June 21, 2017

RE: License Amendment Request for Western Nuclear Inc., Split Rock Mill Site, Source Material License SUA-56.

Figure 2 Conservative Predicted Groundwater Nitrate Plume at 1,000 Years

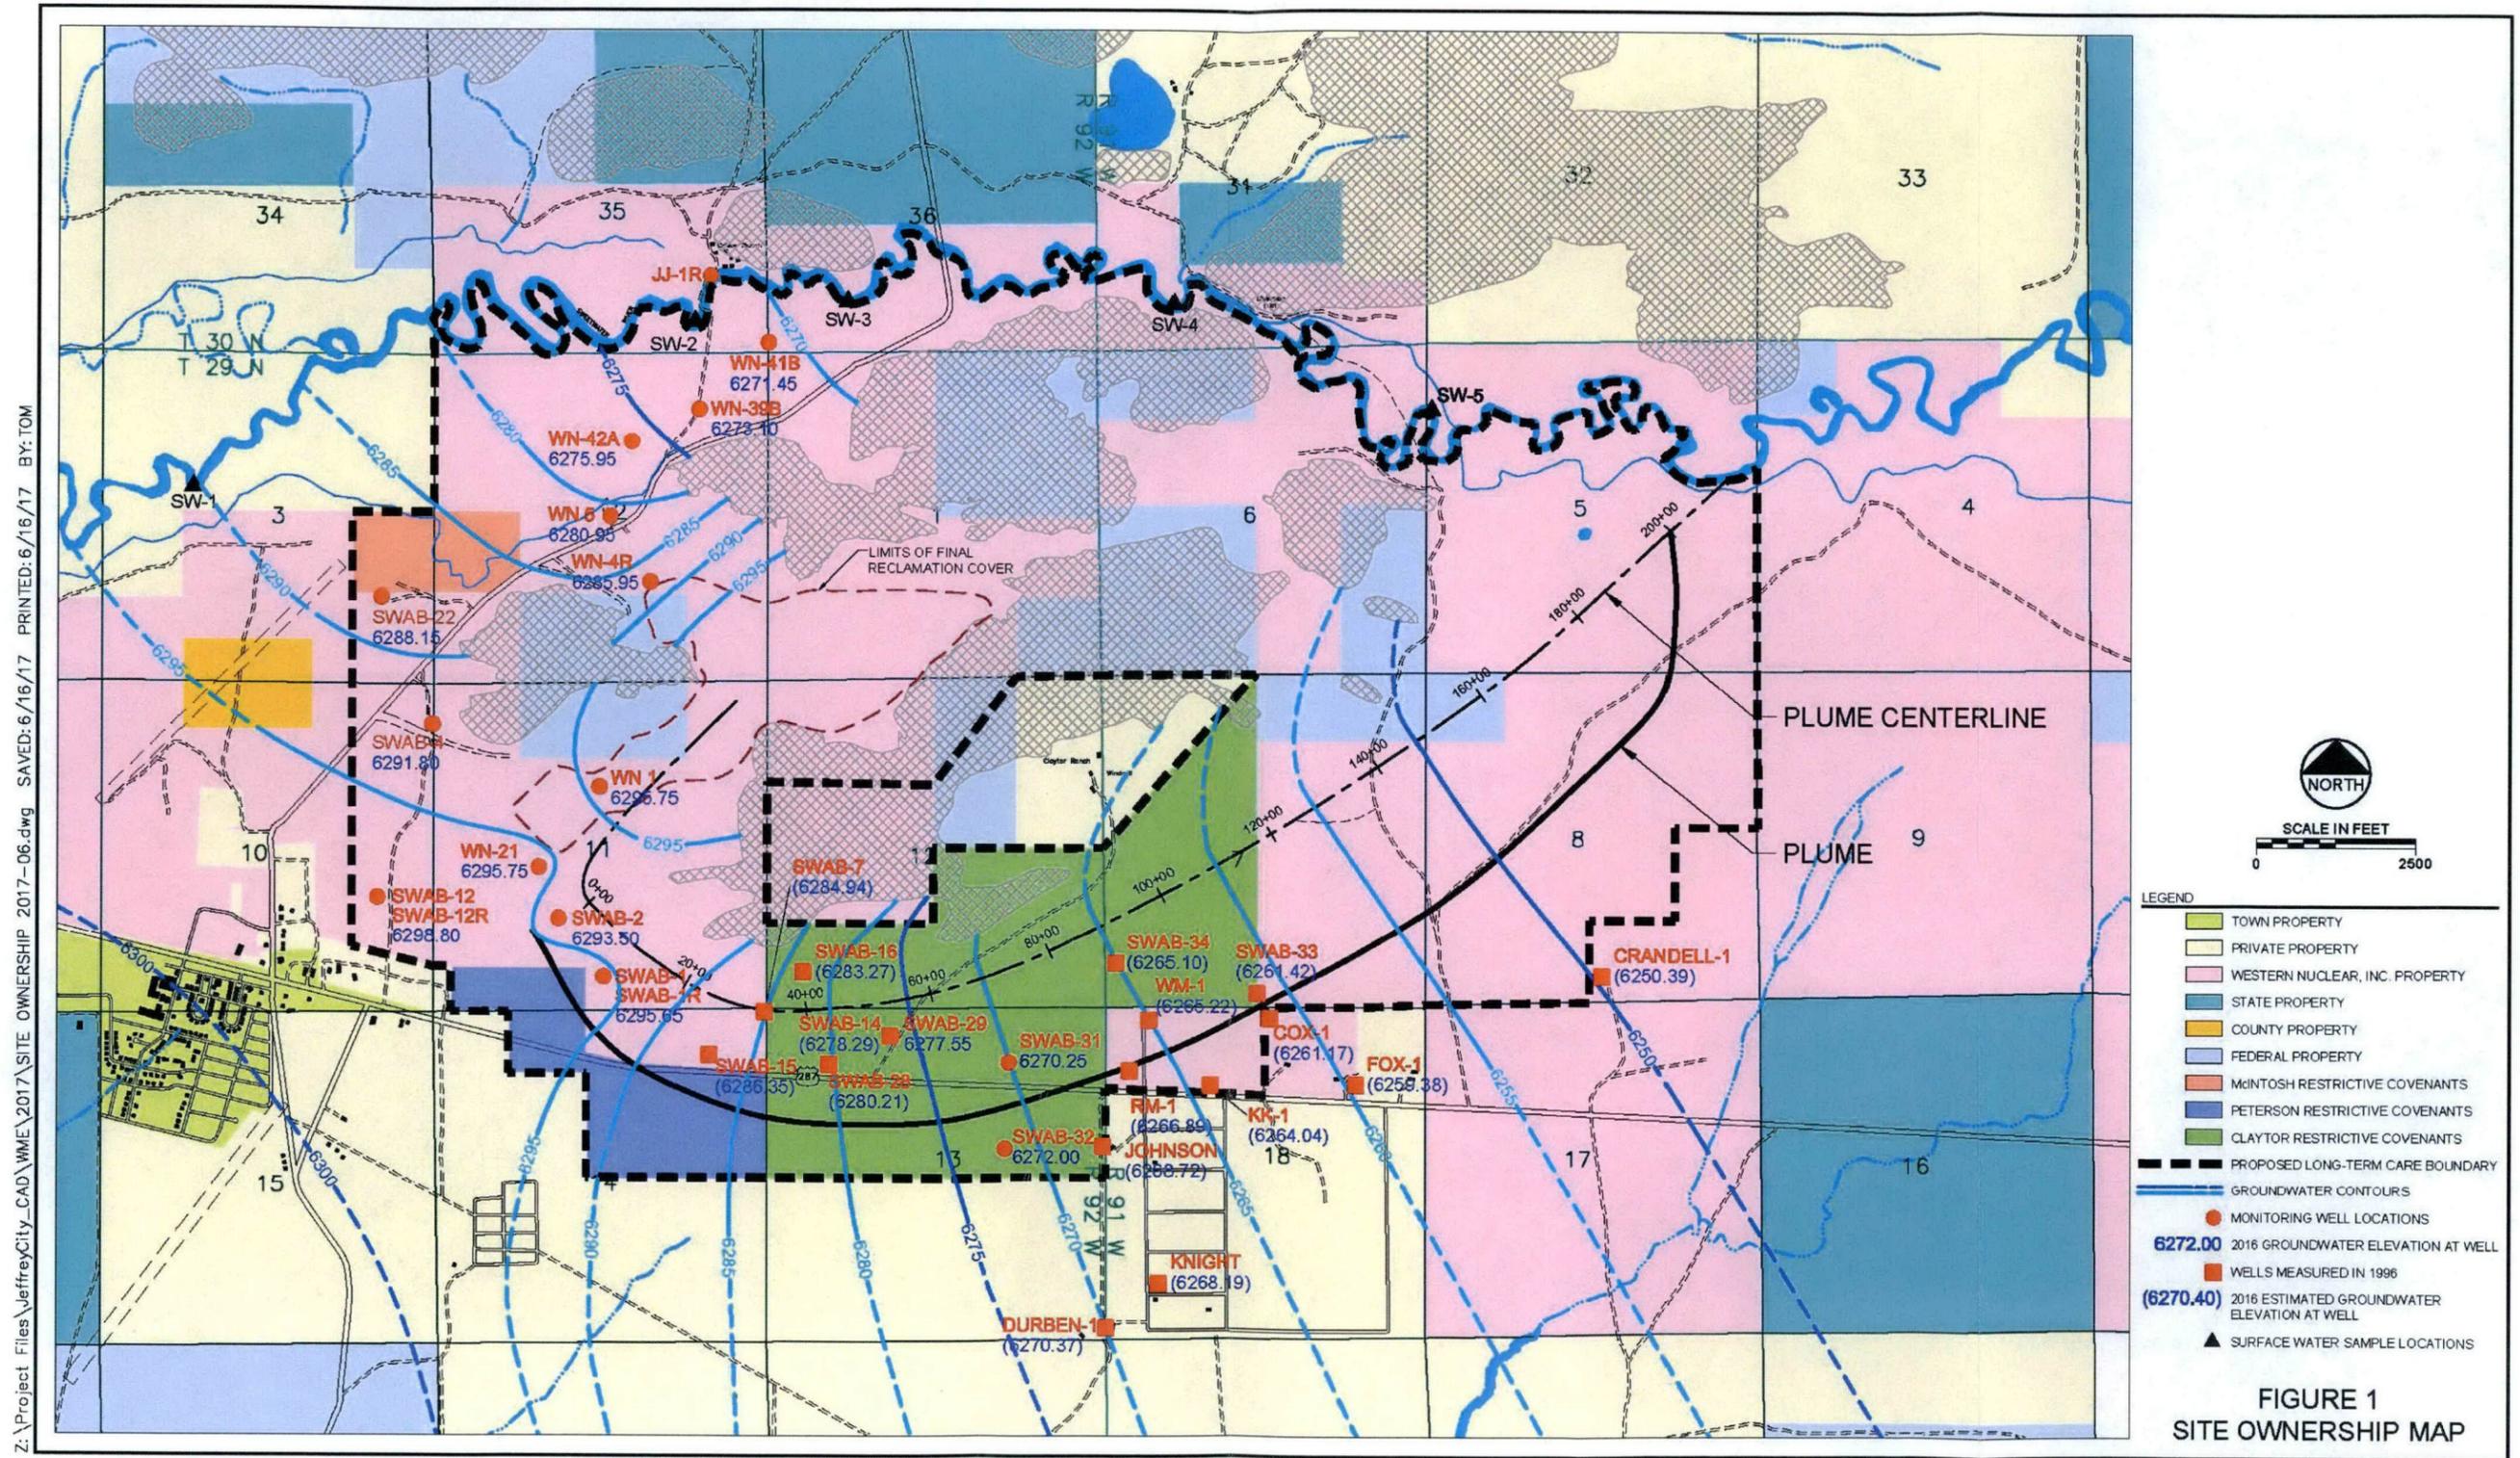
1. DOE staff wanted to confirm the relationship between the predicted nitrate plume extent and the proposed LTSB given the Site specific hydrologic conditions. Therefore, it was requested that WNI plot the predicted nitrate plume with Site groundwater potentiometric contours and proposed LTSB to clearly indicate the relationship between the predicted plume dimensions, the Site hydrologic conditions, and the proposed LTSB.
2. Resolve differences between current measured heads in SWAB-2 (6,293.50 feet [ft.] above mean sea level [amsl] for 2<sup>nd</sup> half 2016) and the head assumed in the modeling (6,292.0 ft. amsl).

As presented in the October 2016 submittal, Table 2 presents the predicted nitrate plume width at different distances from the model origin (SWAB-2) based on the model results included as Figure 2. These data have been used to plot the southern and eastern margin of the predicted plume with respect to the current groundwater potentiometric elevations on Figure 1.

The calculated uniform gradient used in the analytical nitrate transport model presented in October 2016 used a head at the source (SWAB-2) of 6,292.0 ft. amsl and a head of 6240.0 ft. at the Sweetwater River at the eastern margin of Section 5 and a flow distance for 21,310 ft., resulting in a uniform and constant gradient of approximately 0.00244 ft./ft. A rounded value of 6,292.0 was used as groundwater elevations in SWAB-2 have varied to as low as 6,292.7 as recently as 4 years ago (2014). If a source head of 6,293.5 had been used instead, the calculated gradient would have been 0.00251 ft./ft., a difference of 0.00007 ft./ft. or less than 3% relative percent difference in gradient. This difference is inconsequential given highly conservative constant source concentration used and the fact that groundwater elevations over the flow domain are expected to rise and fall by at least this amount during the next 200 to 1,000 years. This difference does not materially impact the highly conservative predicted extent of the nitrate plume or its relationship to the proposed LTSB.
